PCI-SIG ENGINEERING CHANGE NOTICE

Title of ECN:	Root Complex Topology Discovery
Date:	8.12.03
Affected Documents:	PCI Express Base Specification 1.0a
Sponsor:	Ramin Neshati (Intel)

Figure 6-10 Root Complex represented as a single component

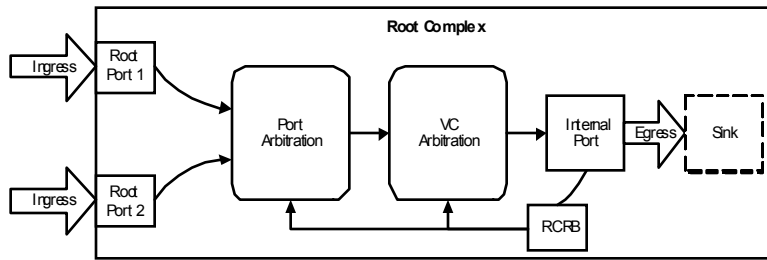
- A single opaque Root Complex such that software has no visibility with respect to internal operation of the Root Complex. All Root Ports are independent of each other from a software perspective; no mechanism exists to manage any arbitration among the various Root Ports for any differentiated services.
- A single Root Complex Component such that software has visibility and control with respect to internal operation of the Root Complex Component. As shown in Figure 6-10, software views the Root Ports as ingress ports for the component. The Root Complex internal port for traffic aggregation to a system egress port or an internal sink unit (such as memory) is represented by an RCRB structure. Controls for differentiated services are provided through a PCI Express Virtual Channel capability structure located in the RCRB.

Figure 6-11 Root Complex represented as multiple components

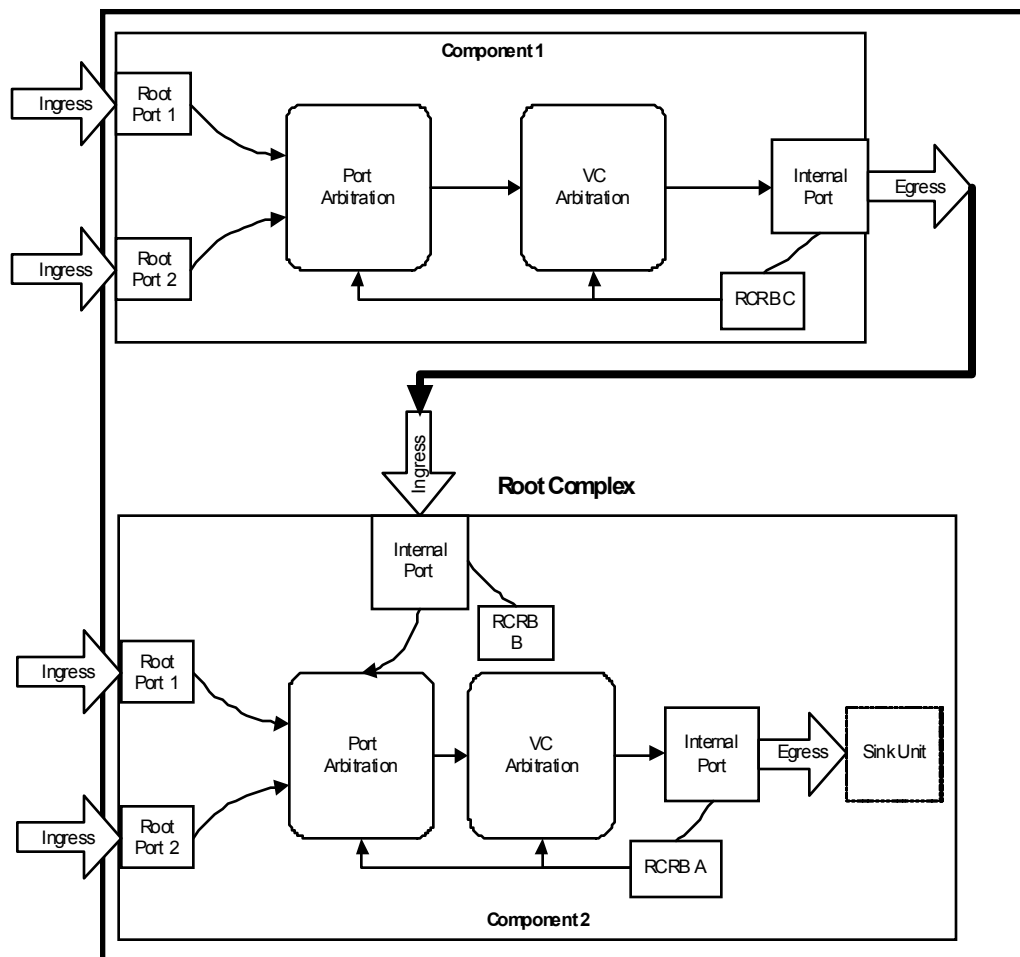
- Multiple Root Complex Components such that software not only has visibility and control with respect to internal operation of a given Root Complex Component but also has the ability to discover and control arbitration between different Root Complex Components. As shown in Figure 6-11, software views the Root Ports as ingress ports for a given component. An RCRB structure controls egress from the component to other Root Complex Components (RCRB C) or to an internal sink unit such as memory (RCRB A). In addition, an RCRB structure (RCRB B) may also be present in a given component to control traffic from other Root Complex Components. Controls for differentiated services are provided through PCI Express Virtual Channel capability structures located appropriately in the RCRBs respectively.

Figure 7-56 PCI Express Root Complex Link Declaration Capability

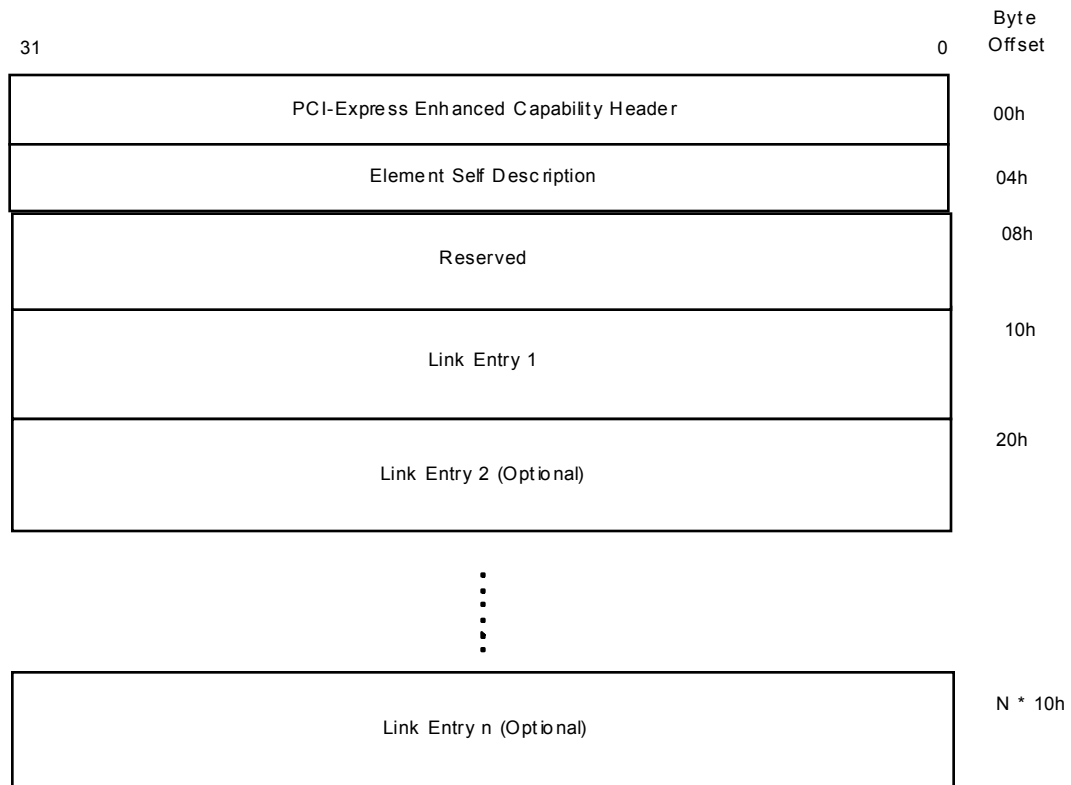
The PCI Express Root Complex Link Declaration Capability, as shown in Figure 7-56, consists of the PCI Express Enhanced Capability Header and Root Complex Element Self Description followed by one or more Root Complex Link Entries.

Figure 7-59 Link Entry

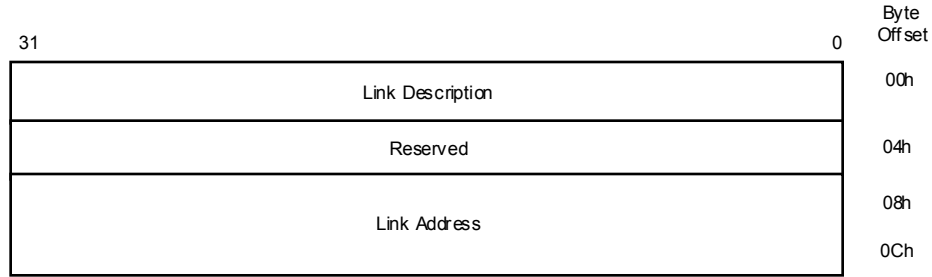
Link Entries start at offset 10h of the PCI Express Root Complex Link Declaration Capabilities structure. Each Link Entry consists of a link description followed by a 64-bit link address at offset 08h from the start of link entry identifying the target element for the declared link. A Link Entry declares an internal link to another Root Complex Element.

Figure 7-61 Link Address for Link Type 0

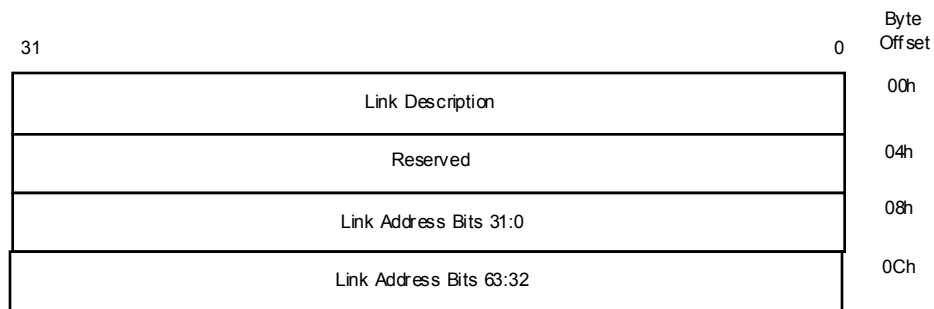
For a link pointing to a memory-mapped RCRB (Link Type = 0), the first DWORD specifies the lower 32-bits of the RCRB base address of the target element as shown below; bits 11:0 are hardwired to 0 and reserved for future use. The second DWORD specifies the high order 32-bits (63:32) of the base address of the target element.

Figure 7-62 Link Address for Link Type 1

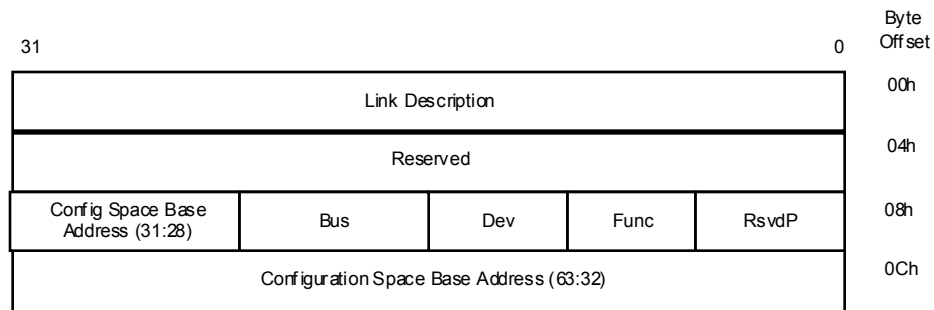
For a link pointing to the configuration space of a Root Complex element (Link Type = 1), Bits 27:12 of the first DWORD specify the bus, device and function number of the configuration space of the target element as shown in the table

below; bits 11:0 are reserved and hardwired to 0. Bits 31:28 of the first DWORD together with the second DWORD optionally identify the target element's hierarchy (for multi-hierarchy systems) by specifying bits 63:28 of the configuration space base address of the PCI Express hierarchy associated with the targeted element; single hierarchy systems that do not implement more than one memory mapped configuration space are allowed to report a value of 0 to indicate default configuration space.

A configuration space base address [63:28] equal to zero indicates that the configuration space address defined by bits [27:12] (bus, device number, and function number) exists in the default configuration space segment; any non-zero value indicates a separate configuration space base address.

Figure 7-63 Root Complex Internal Link Control Capability

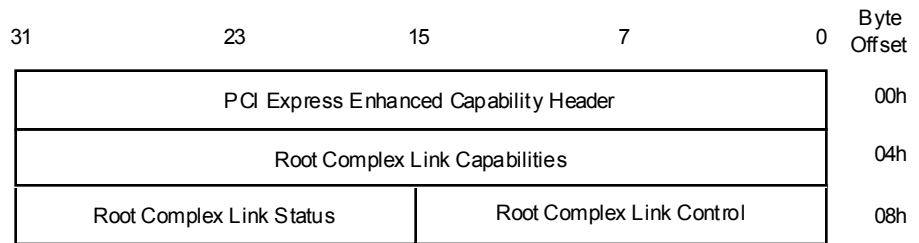
The PCI Express Root Complex Internal Link Control Capability is an optional capability that controls an internal Root Complex link between two distinct Root Complex Components. This capability is valid for RCRBs that declare element type as Internal Link in the Element Self-Description register of the Root Complex Link Declaration Capability structure.

The Root Complex Internal Link Control Capability Structure is defined as shown in the following figure:

Figure 7-65 Root Complex Link Capabilities Register

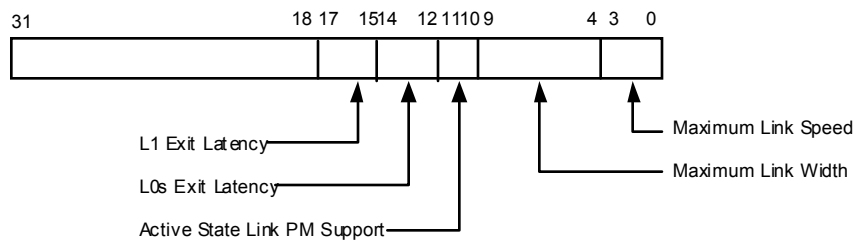
The Root Complex Link Capabilities register identifies capabilities for this link.

Figure 7-66 Root Complex Link Control Register

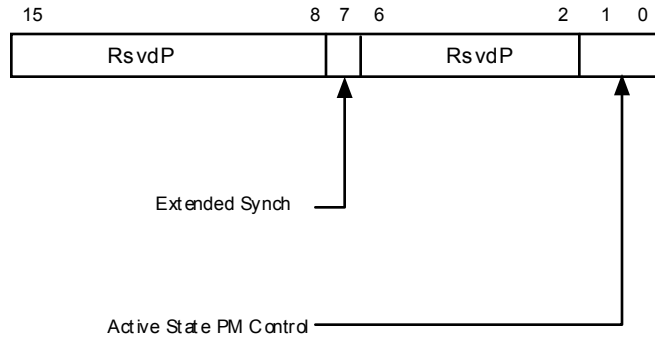
The Link Control register controls parameters for this internal link.
